MEMORANDUM **Case # 16- 15**

SUBJECT: Proposed Addition of Traffic Rated Box

DETAIL NO.				REVISED	DETAIL NO.
319	MARICOPA ASSOCIATION of GOVERNMENTS	STANDARD DETAIL ENGLISH	TRAFFIC RATED BOX AND COVER	1–1–2017	319

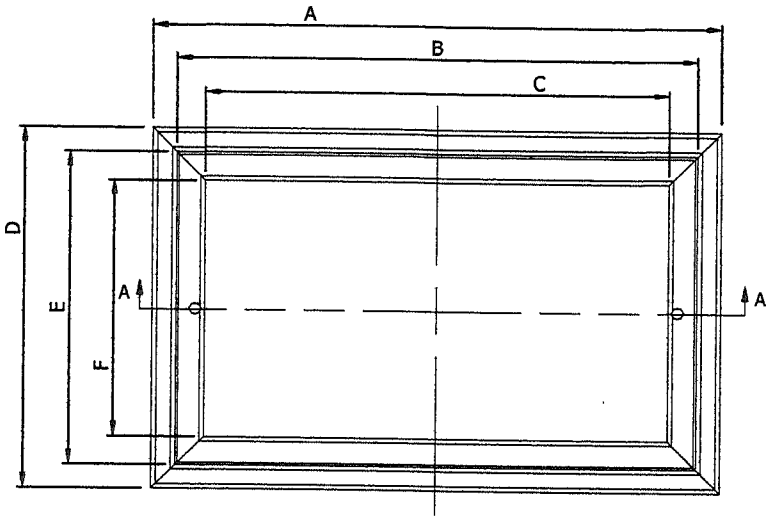
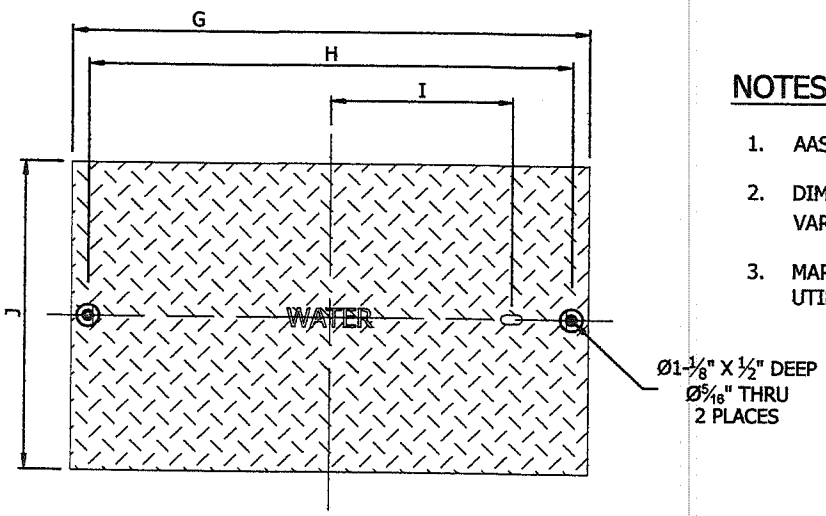
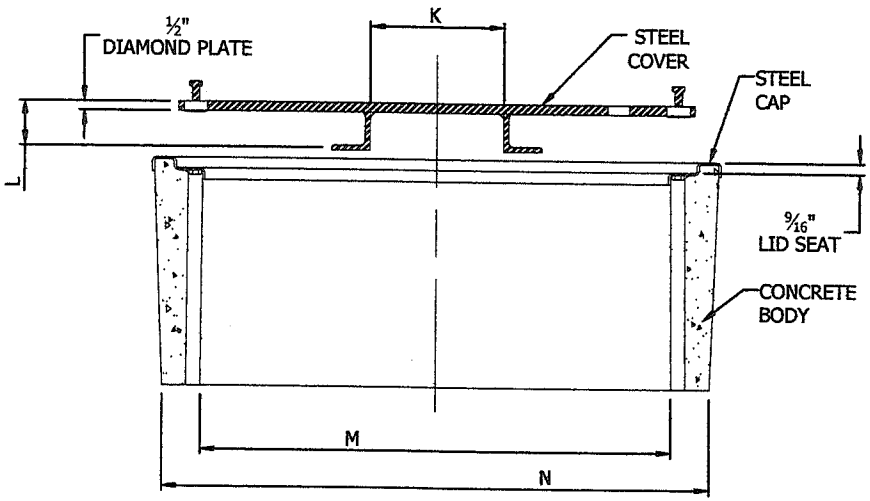
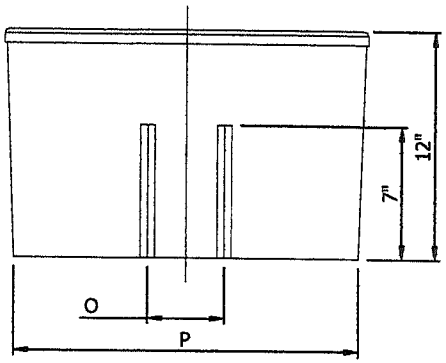
Purpose: Need for box that can withstand AASTHO H20 rating

Proposal: Address the situation when a pedestrian rated box will not do. Add two industry standard size boxes that will address this need. These boxes will meet H20 loading and can be used in full traffic areas. Design to allow marking to be designated by utility or agency. New proposed detail to be created 319.
